Application No.: 09/994,693

For: OPTICAL PICKUP DEVICE WITH
EXTERNAL PHOTODETECTING
UNIT (as amended)

SUBMISSION OF REPLACEMENT DRAWINGS

Fig. 1

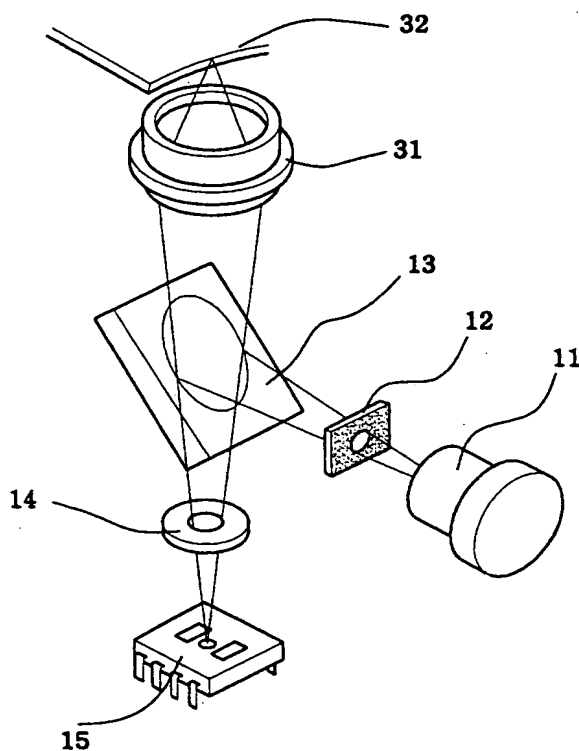
A Submission of Replacement Drawing Sheets is filed concurrently herewith, to add the legend "Prior Art" to Figures 1 and 2. Figure 3 has been amended in accordance with the Examiner's suggestion to change the designator of the substrate for the detecting unit from "126" to

Filed herewith are 3 replacement sheet of drawings containing Figures 1, 2 and 3. These replacement sheet of drawings are submitted to add the legend "Prior Art" to Figures 1 and 2. Figure 3 has been amended in accordance with the Examiner's suggestion to change the designator of the substrate for the detecting unit from "126" to --121--. It is requested that this drawing be approved and made part of the official record in the above-identified patent application.

PRIOR ART
